557 CONGRESS STREET

APPLICATION FOR PERMIT TO ERECT
SIGN OVER PUBLIC SIDEWALK OR STREET

Memorandum from Department of Building Inspection, Portland, Maine
Erection of projecting sign for Regal Shoe Co. at 555 Congress Street by United Neon Display

At 555 Congress Street-1
(Projecting sign)

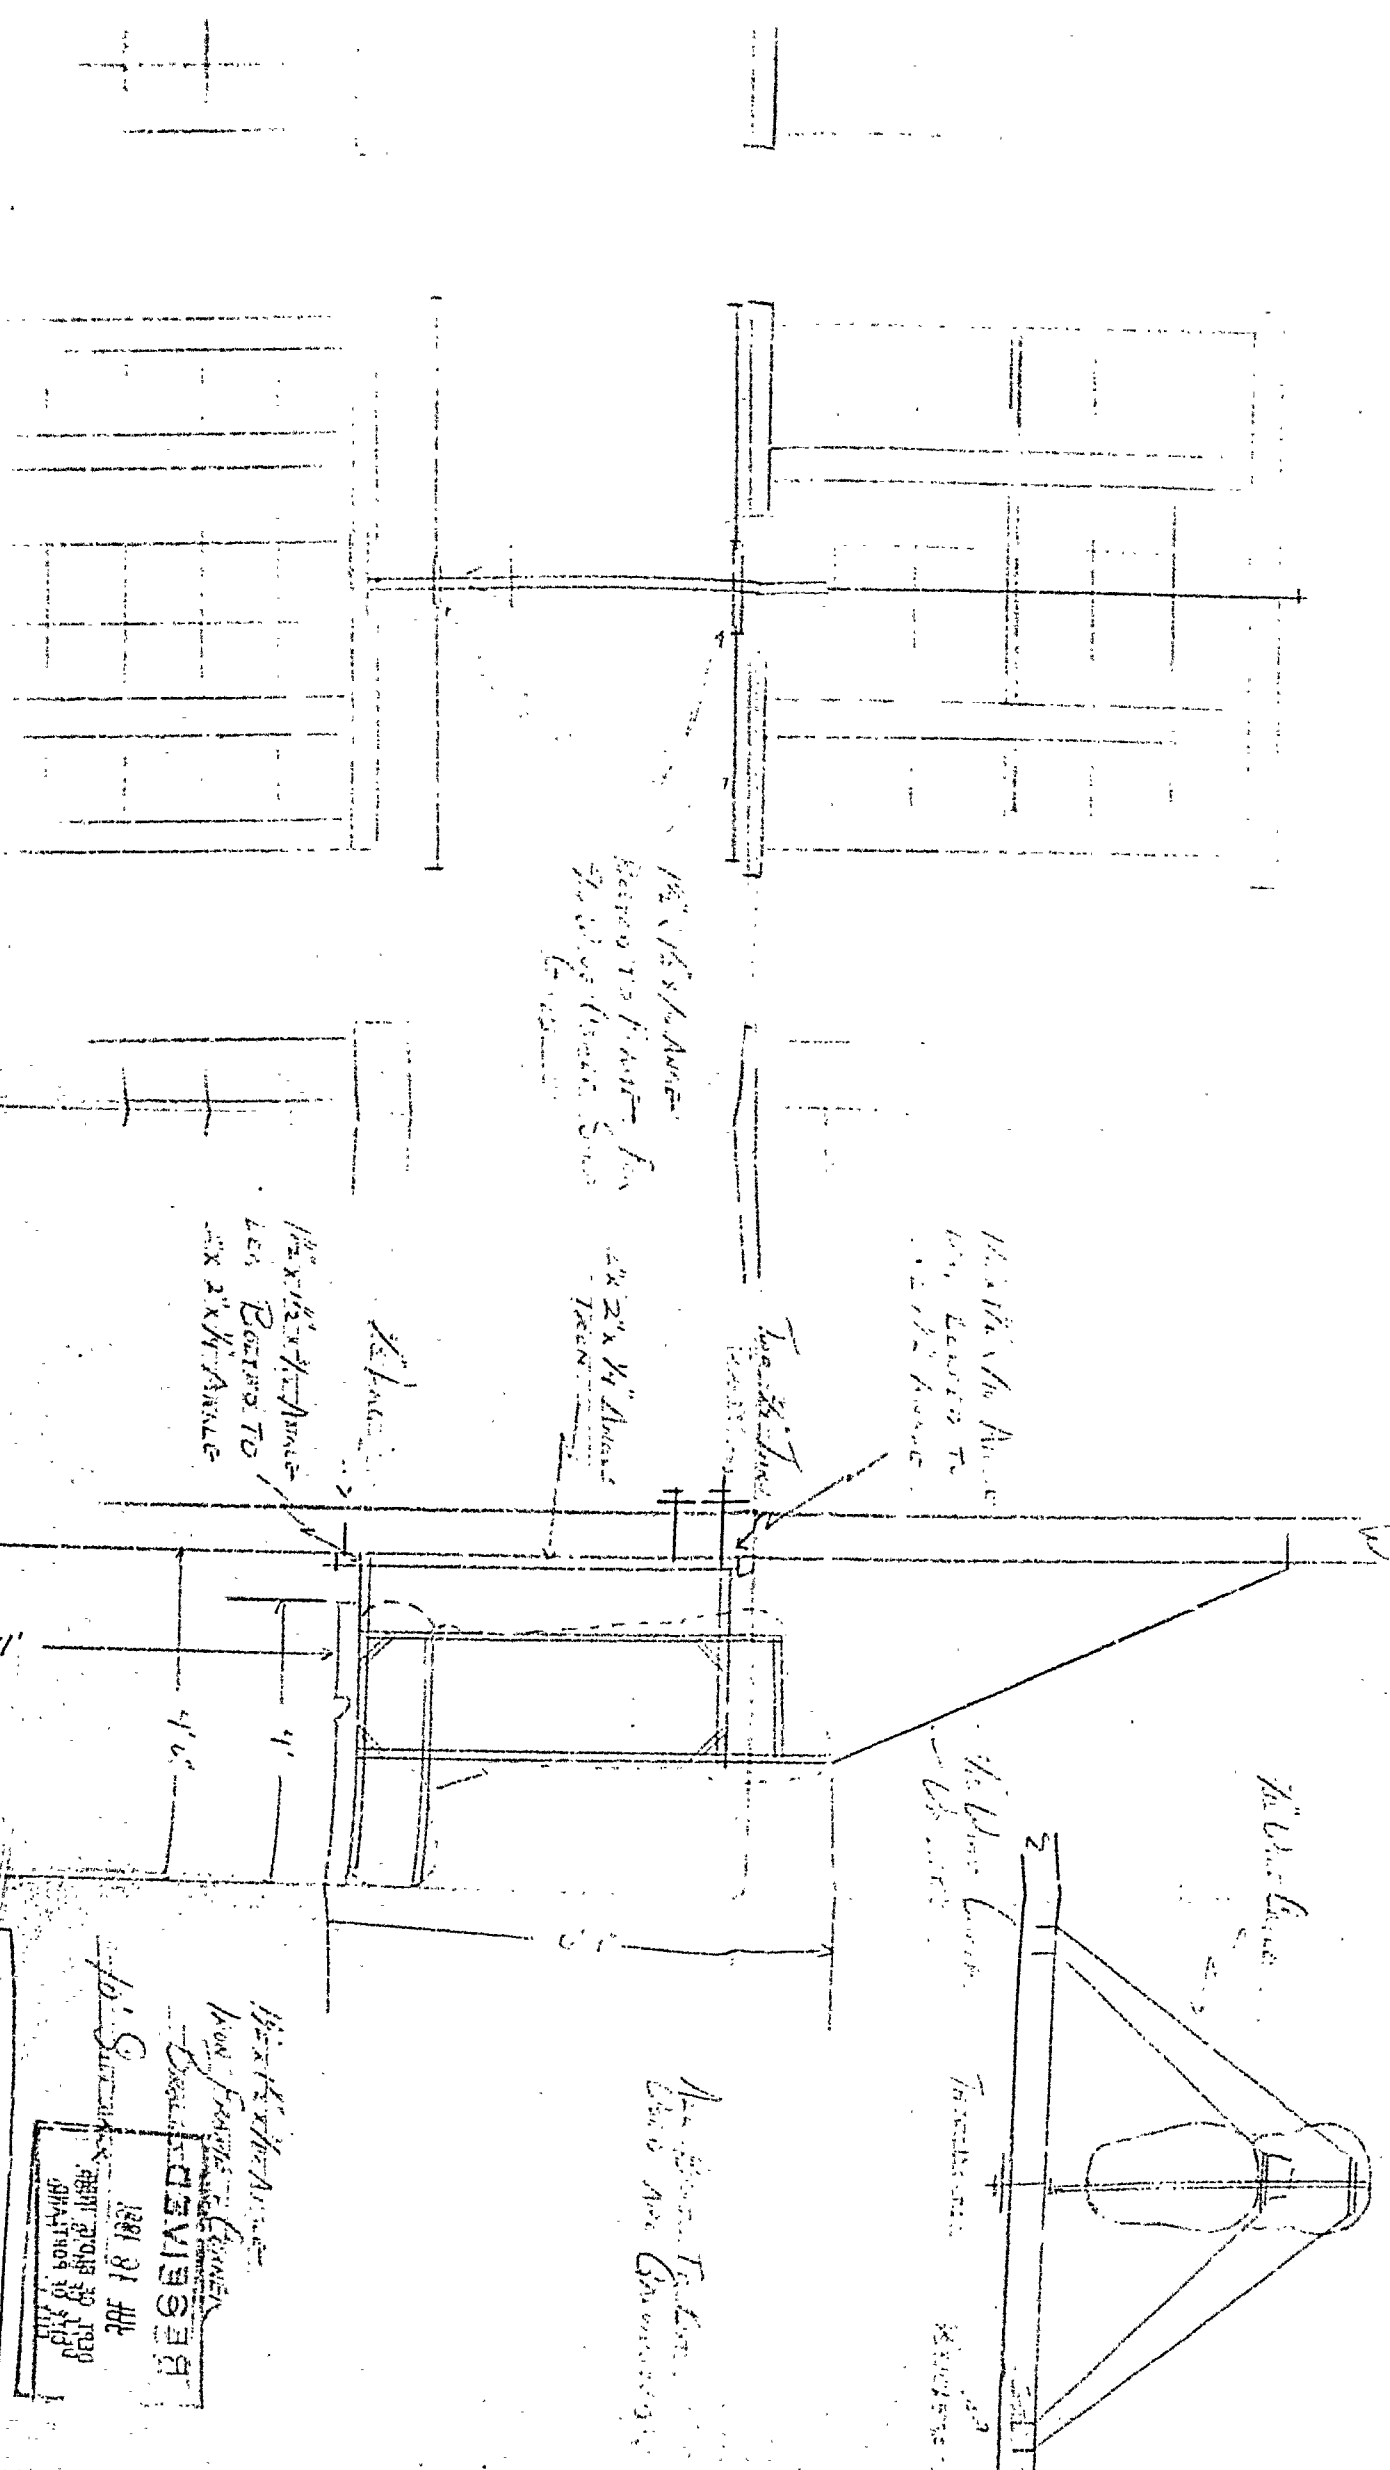
If the Mr. Gregory's plan of the projecting sign proposed for the Regal Shoe Company at 555 Congress Street, is understood, the arrangement of structural steel frame and the guys is not adequate.

In usual the requirement is for a rigid frame outlining the entire sign as far as possible and with all side guys and uplift guys fastened to the main horizontal members of the frame. The plan seems to indicate that an auxiliary angle is placed top and bottom and that the side guys are fastened to it rather than to the rigid frame. If possible the interior rigid structural frame should cover a greater height of the sign.

Application of plan shows through bolts over the top of the sign apparently intended to fasten a vertical piece of steel 3/8" x 1/2" to the building and a horizontal piece of steel flat against the building the horizontal members of the structural frame are to be fastened in some manner. While the position of the through bolts may be adequate, it is not clear how the horizontal members of the frame are to be fastened to the bar against the wall. If these connections are to be welded, the welding operator is required to be certified in this department and to have his certificate indicating that certification within one year prior to the date of doing the welding.

There is also objection in Section 211c2.1 of the Building Code to having the upper guys pass in front of the two windows indicated on the plan. Some other arrangement is necessary so that the guys will not be in front of the windows and so that they would not prevent the fire department from erecting a ladder to reach the windows. Perhaps one rigid side guy would accomplish this purpose.

We also need the assurance in writing that all connections between the aluminum encasement and steel will be properly made with such type of bolts and properly protected so that corrosion will not be set up between the aluminum and the steel at any point.

Please revise the plan to show the above corrections rather than attempting to mark over the plan we have.
